# Keystone RV Company

## SAFETY ADVISORY # 26-483

### Touring Coil Suspension Shock Bolt Replacement

# TOURING COIL SUSPENSION SHOCK BOLT REPLACEMENT

Fig. 1

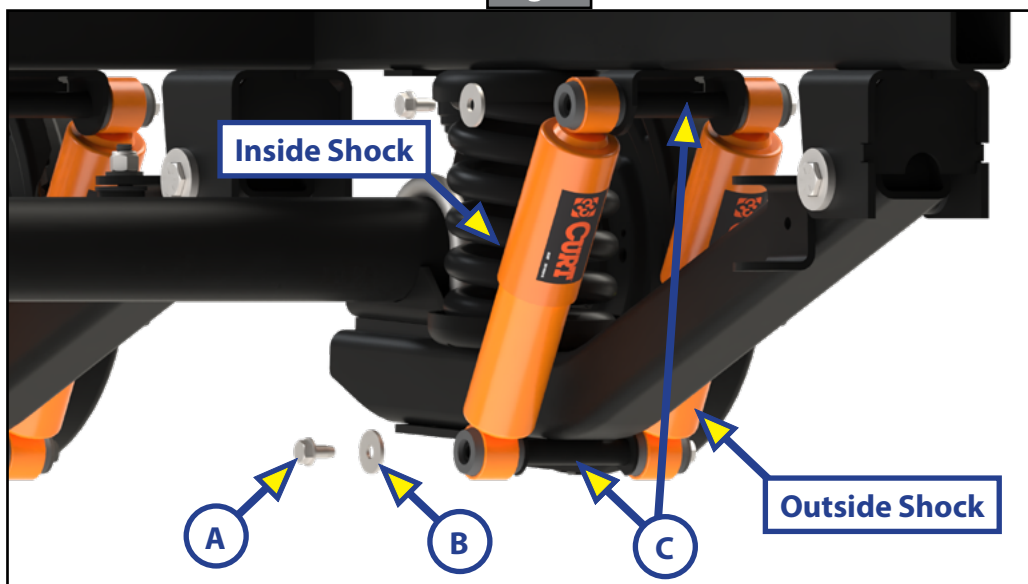
1. Starting with the inside shocks, loosen and remove the two existing 3/8"-16 x 3/4" thread forming screws (Fig. 1A) and washers (Fig. 1B) securing each shock absorber onto its posts (Fig. 1C). Retain washers (PN 249853) for reinstallation in Step 2.

2. Reinstall previously-removed washers onto two new 3/8" - 16 x 3/4" Grade 8 hex head bolts.

**Fig. 3**

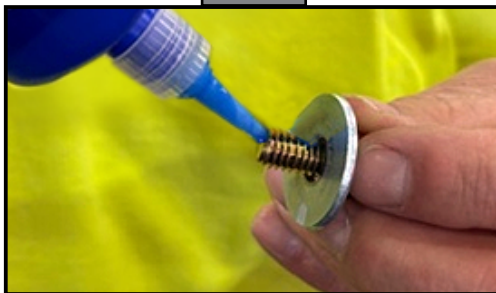
7. Once all bolts have been tightened to 20-30 ft-lbs spec, apply a green or yellow dot of epoxy paint (Fig. 3A) onto the newly-installed bolt to indicate completed repair status.
